Development Control Unit

26 June 2024 at 2pm

ITEM NO	: 2.1
SUBJECT	: 2PM 24 ROCHER AVENUE, HUNTERS HILL
STRATEGIC OUTCOME	: DEVELOPMENT APPLICATION, REGULATION AND MONITORING SERVICES ARE STREAMLINED
ACTION	: DEVELOPMENT APPLICATIONS (DAS) ARE PROCESSED IN ACCORDANCE WITH SERVICE STANDARDS
REPORTING OFFICER	: PATRICK OGISI
DEVELOPMENT APPLICATION NO	20230156
PROPOSAL	DEMOLITION OF THE EXISTING BUILDING AND CONSTRUCTION OF A NEW ATTACHED DUAL OCCUPANCY WITH STRATA SUBDIVISION AND ASSOCIATED LANDSCAPING
APPLICANT	MINJUN YAO
OWNER	MR A MOHAREB
DATE LODGED	29 NOVEMBER 2023

ITEM NO	: 2.2
SUBJECT	: 2.30PM 22 FARNELL STREET, HUNTERS HILL
STRATEGIC OUTCOME	: DEVELOPMENT APPLICATION, REGULATION AND MONITORING SERVICES ARE STREAMLINED
ACTION	: DEVELOPMENT APPLICATIONS (DAS) ARE PROCESSED IN ACCORDANCE WITH SERVICE STANDARDS
REPORTING OFFICER	: PATRICK OGISI
DEVELOPMENT APPLICATION NO	20240032
PROPOSAL	EXISTING ALFRESCO ROOF CONVERT TO BALCONY, AND ADD ONE SMALL WINDOW AT BATHROOM OF MASTER BEDROOM.
APPLICANT	TIMOTHY SHU
OWNER	MR T SHU
DATE LODGED	22 APRIL 2024

Figure 1. Taken from the neighbouring property with a view of the subject dwelling where the proposed balcony is to be located on the currently non trafficable roof

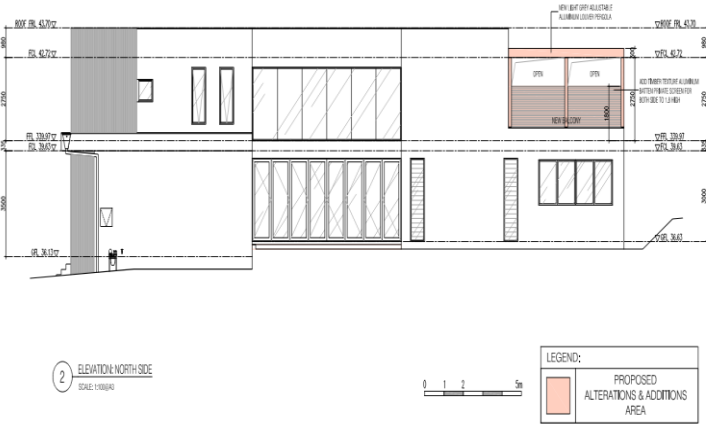
The residents of 24a Farnell Street raised first and foremost as a concern their potential loss of views. The views on this aspect can be seen in Figure 1. Section 3.5.5 of the Hunters Hill Development Control Plan 2013 discusses view sharing. The objectives are to:

As can be seen in Figure 1, the view in question from 24a Farnell Street is of trees and a house and not the city skyline or surrounding riparian areas.

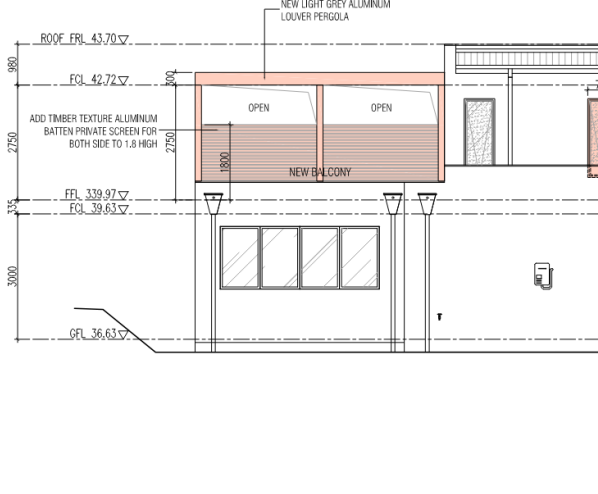
20 Farnell Street is 62.76 metres, with a rear setback of 16.26 metres to serve as a corridor for unobstructed sunlight. This is considered to be sufficient solar access with a minimal reduction.
Increase in Building Footprint	As the proposed balcony is going on top of a currently non-trafficable roof, the footprint of the dwelling remains the exact same as it currently is. There is only an increase to the trafficable area, which is to be accessible from a master bedroom.
Katie Mackey 20 Farnell Street, Hunters Hill CONCERNS RAISED	
Diminished Privacy	Figure 3 shows the presence of a privacy screen with closable louvres. This time from the southern aspect. This mitigates any potential privacy impacts, both from a visual and acoustic angle.
Solar Access	The existing balcony has a width of 5.96 metres. This is the corridor of sunlight that will be affected into 20 Farnell's private open space. For reference, the site boundary with 20 Farnell Street is 62.76 metres, with a rear setback of 16.26 metres to serve as a corridor for unobstructed sunlight. This is considered to be sufficient solar access with a minimal reduction.
